**PLANNED UNIT DEVELOPMENT
& SUBDIVISION STAFF REPORT****Date: May 1, 2014****DEVELOPMENT NAME**

Battlehouse Parking Deck Two Subdivision

10 North Royal Street
(Northeast corner of North Royal Street and Dauphin Street
extending to the Southwest corner of North Water Street
and St Francis Street)

Planned Unit Development Approval to allow two
buildings on a single building site and to allow cross access between two lots, and Subdivision
approval to create 2 lots.

PLANNING COMMISSION VICINITY MAP - EXISTING ZONING

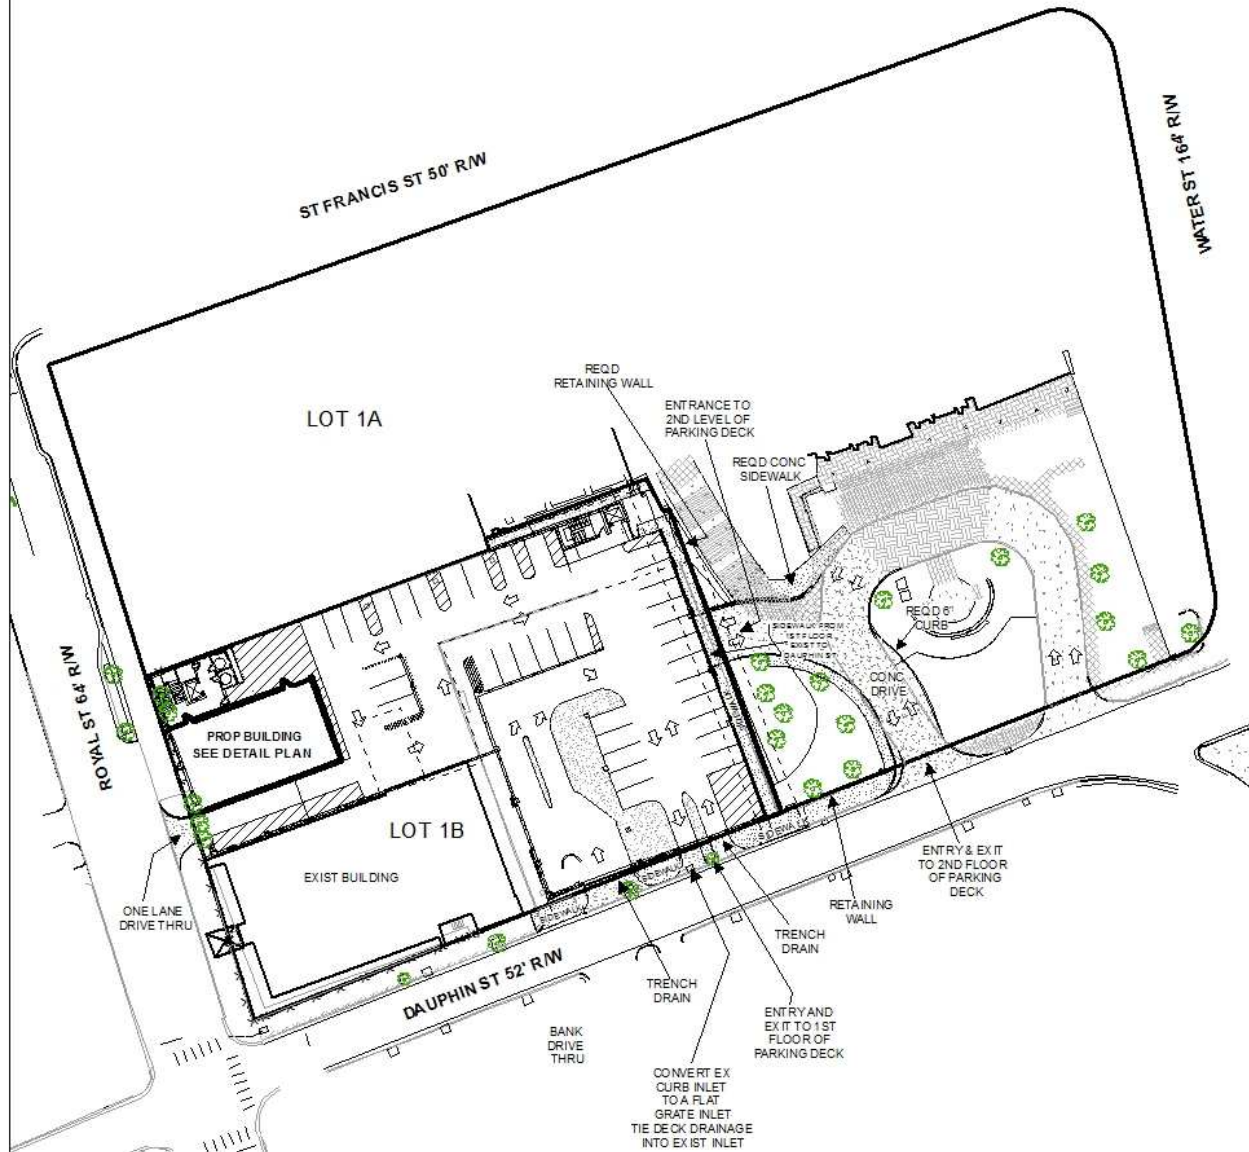
The site is zoned B-4, General Business District, thus the proposed uses are allowed by right.

SITE PLAN

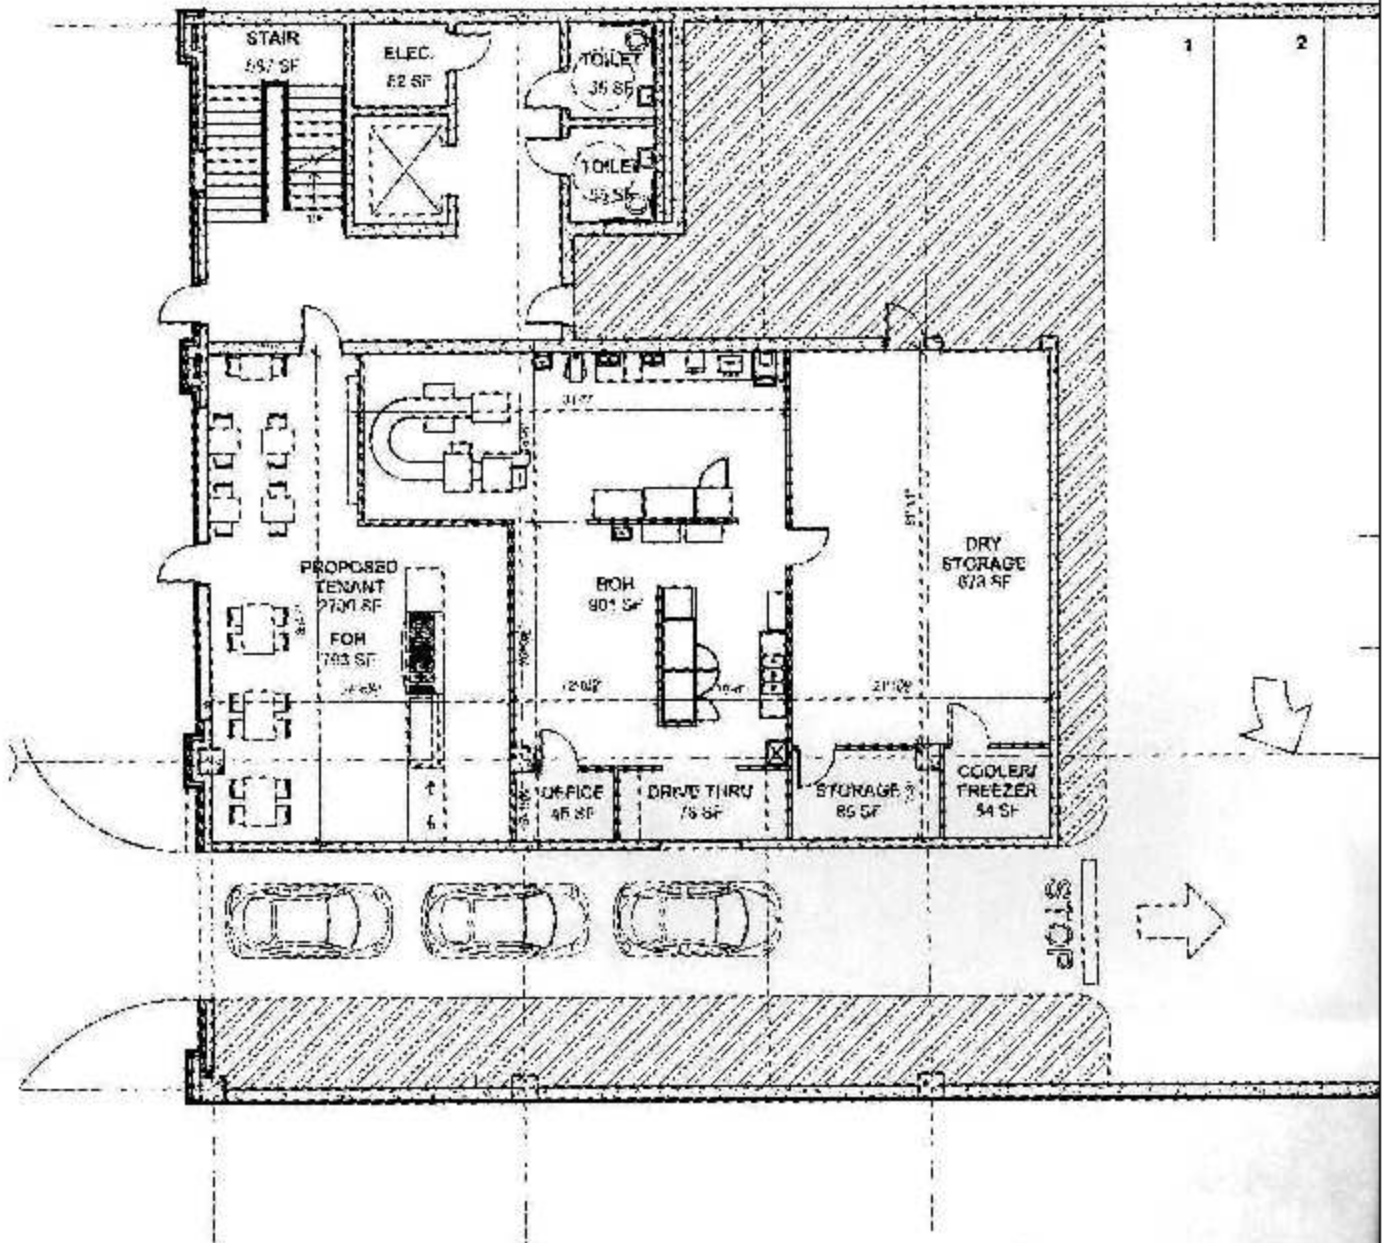
Access to the main parking levels of the proposed parking deck will be from an existing curb-cut and driveway located on Lot 1A. The existing driveway will be modified to link to the second level of the parking deck. It should be noted that there will be no vehicular circulation between the first level of the parking deck and the upper levels.

The proposed restaurant drive-through from the North Royal Street entrance appears to only have a queuing distance of approximately 36 feet: the Zoning Ordinance requires a minimum of 51 feet. The proposed bank drive-through from the Dauphin Street entrance appears to exceed the minimum queuing distance requirement. The Commission may wish to consider waiving the 51 foot requirement of Section 64-4.F. of the Zoning Ordinance for the proposed restaurant drive-through due to the unique urban nature of this site, subject to Traffic Engineering approval.

No dumpster is depicted on the site plan. If a dumpster is proposed, it should be depicted on the site plan, or a statement should be provided indicating how waste will be serviced for the new retail/restaurant and bank uses.

- 7) *Depiction of a dumpster on the site plan, or provision of a statement indicating how waste will be serviced for the new retail/restaurant and bank uses;*

- 8) *Compliance with Section 64-6.A.of the Zoning Ordinance, including the photometric requirements;*
- 9) *Waiver of Section 64-4.F. of the Zoning Ordinance regarding the minimum drive through queuing distance for the restaurant use only, subject to Traffic Engineering approval;*
